**NEW YORK STATE THRUWAY AUTHORITY
DEPARTMENT OF ENGINEERING**

**AMENDMENT NO. 3
TO**

**CONTRACT TANY 26-17B
D215020
REPLACEMENT OF THE PINE HILL ROAD
BRIDGE OVER I-87 AT MP 47.58,
REHABILITATION OF I-87 BRIDGE OVER
SMITH CLOVE ROAD AT MP 47.04,
AND RESURFACING AND SAFETY IMPROVEMENTS
ON I-87 BETWEEN MP 46 AND MP 48
IN THE NEW YORK DIVISION
OF THE NEW YORK STATE THRUWAY
IN ORANGE COUNTY**

TITLE OF PROJECT REPLACEMENT OF THE PINE HILL ROAD BRIDGE AT I-87 MILEPOST 47.58	CONTRACT NUMBER: TANY 26-17B
LOCATION OF PROJECT VILLAGE OF WOODBURY ORANGE COUNTY BIN 5514280	DATE: 01/19/2026
TITLE OF DRAWING SLAB REINFORCEMENT DETAILS (1 OF 2)	DRAWING NUMBER: ST-51

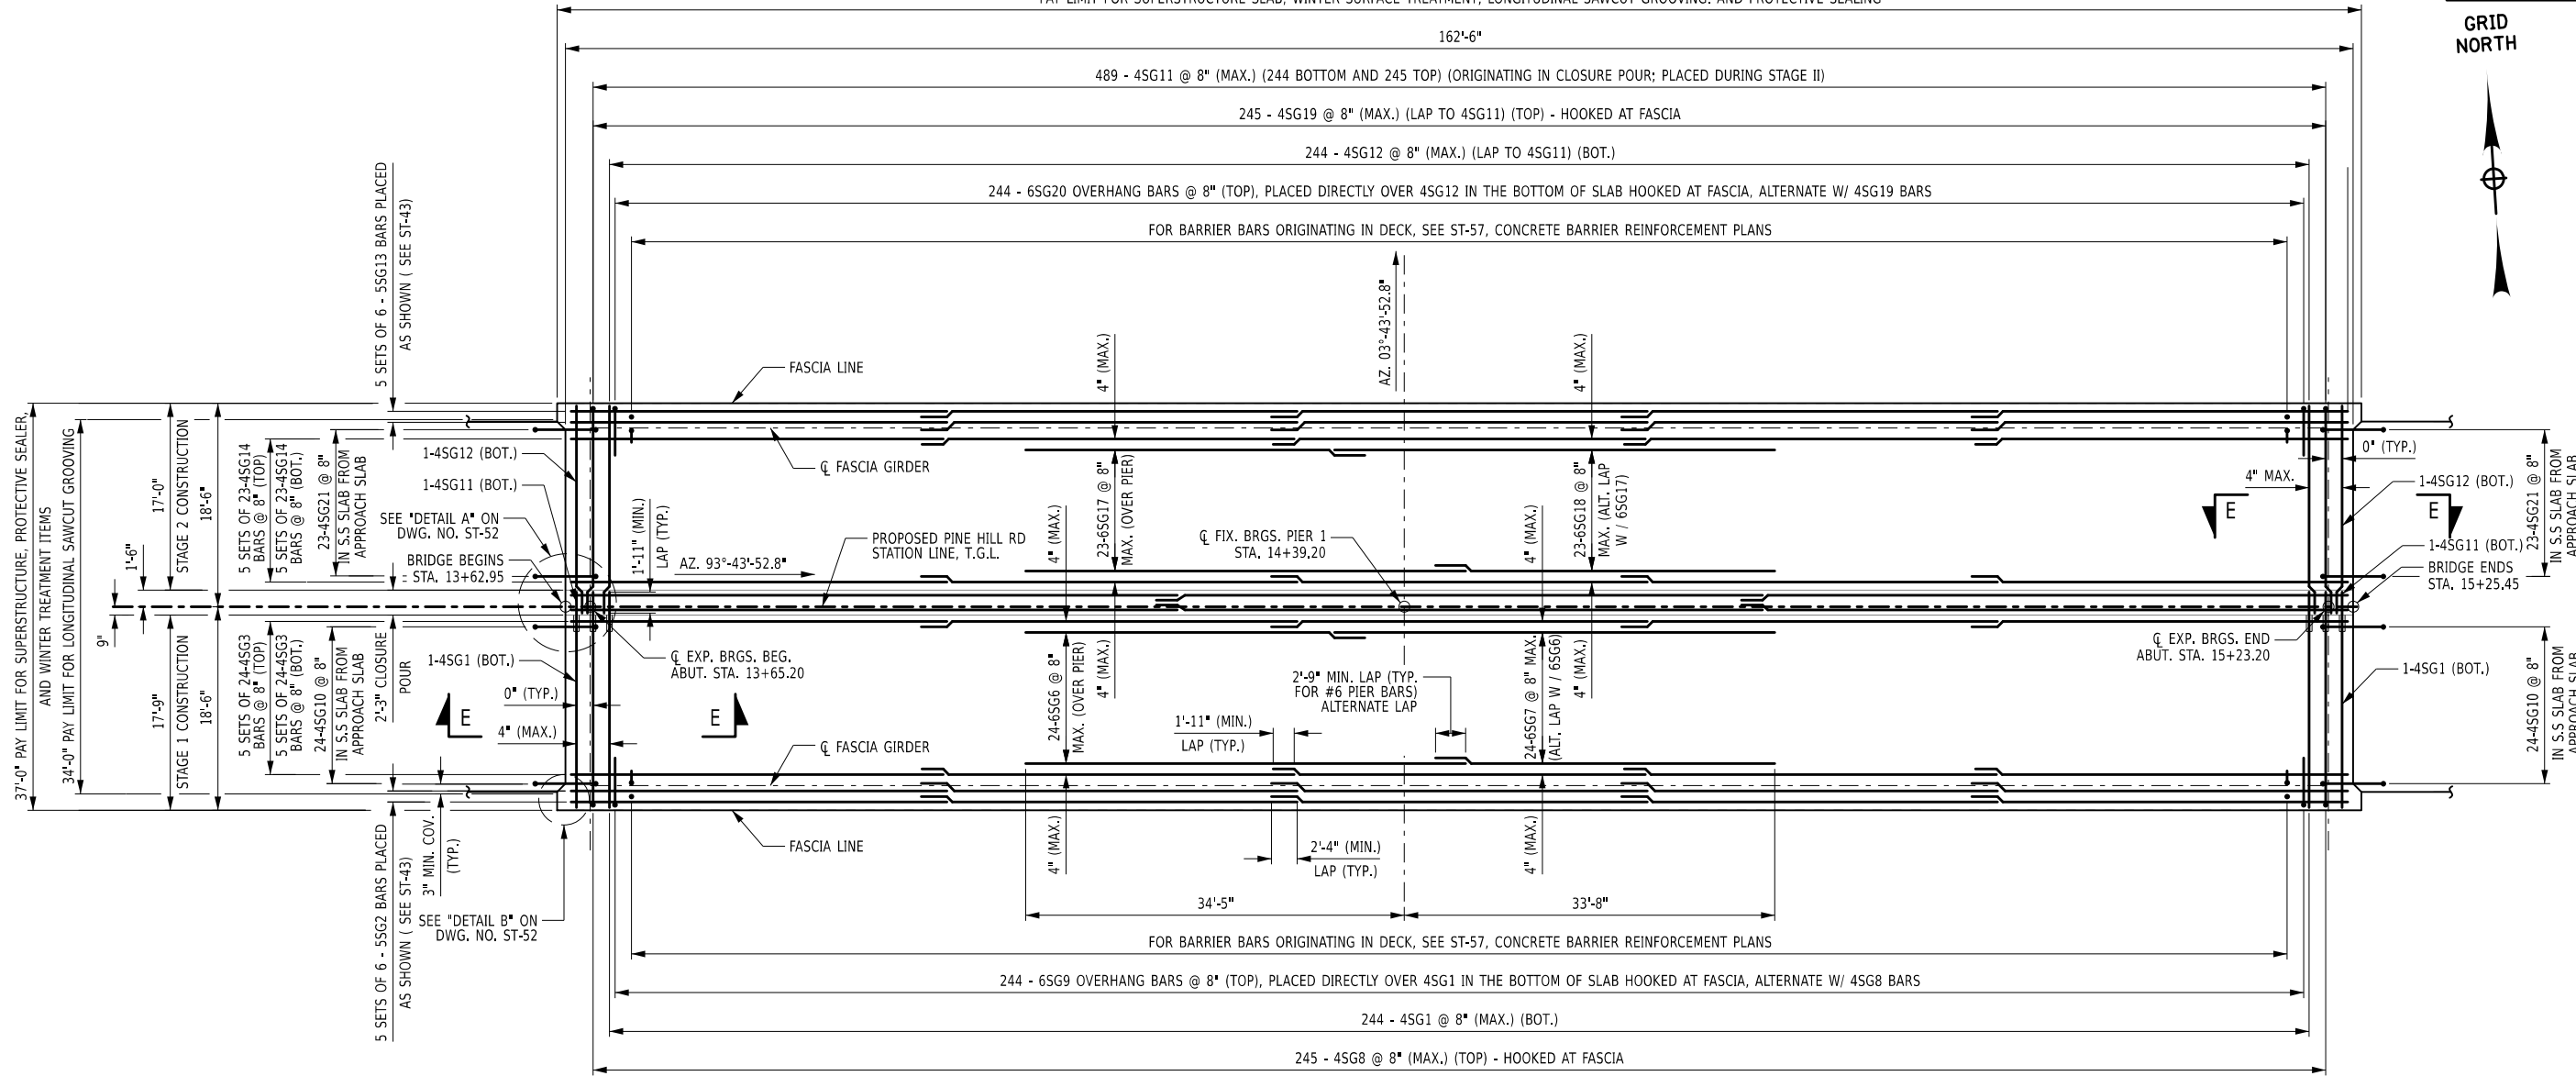
13. **DELETE** Drawing Number ST-51, Sheet 91 of 180, and **SUBSTITUTE** with the attached Drawing Number ST-51, Sheet 91A3 of 180. The quantities for the Protective Sealing of Structural Concrete, to be paid for under Item 559.02, have been updated in the Superstructure Slab Table.
